> Re: Broadwater Energy LLC, Docket No. CP06-54-000 Broadwater Pipeline LLC, Docket Nos. CP06-55-000 & CP06-56-000

November 13, 2006 Correspondence from Broadwater Energy LLC and Broadwater Pipeline LLC to the United States Army Corps of Engineers

RE: Broadwater Energy
FERC Docket Nos. CP06-54-000 and CP06-55-000
USACE Application No. 2006-00265-L6
Response to November 3, 2006 Letter

The following figures have been revised based on USACE comments 1-9 and are provided as Attachment 1:

TYPICAL
TOWED PLOW SECTION
(5 FT. OF COVER)

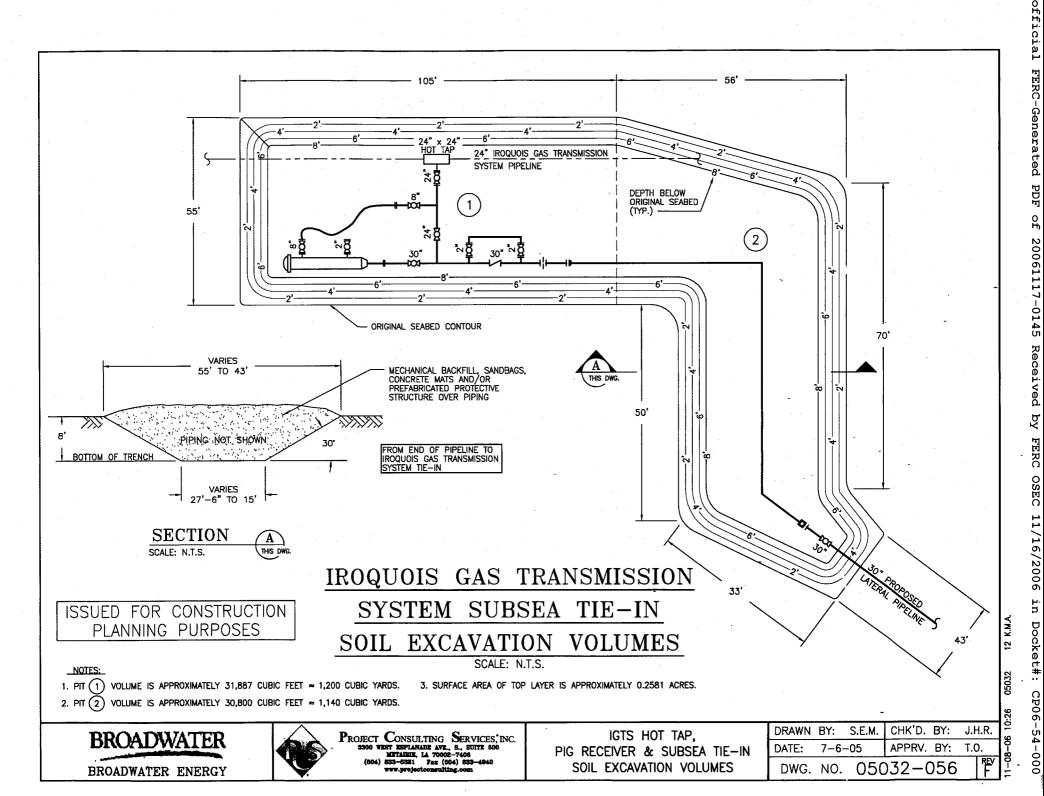
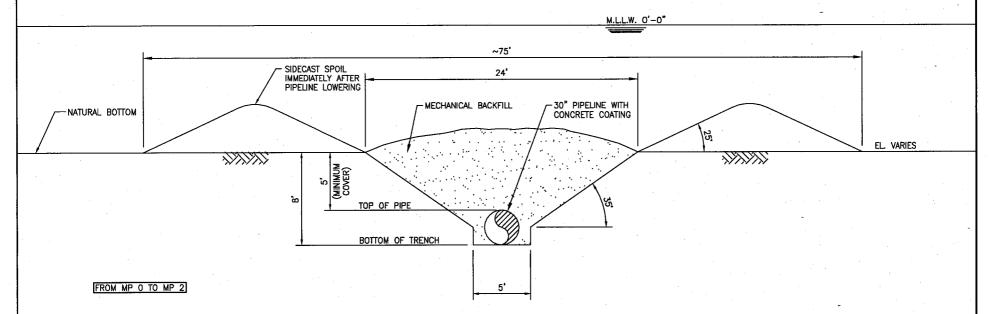
Finally, in Comment 11, the USACE has requested specific clarification as to Broadwater's proposed construction techniques in areas were rock may be encountered (e.g., Stratford Shoal). In addition to modifying the specific drawings, as referenced in your letter, and provided in Attachment 1, Broadwater is including additional text which summarizes specific construction techniques that will be utilized in these specific areas.

Broadwater proposes that pipeline will be lowered so that the top of pipe will be installed three (3) feet or more below the natural bottom using a post-lay plowing technique. In
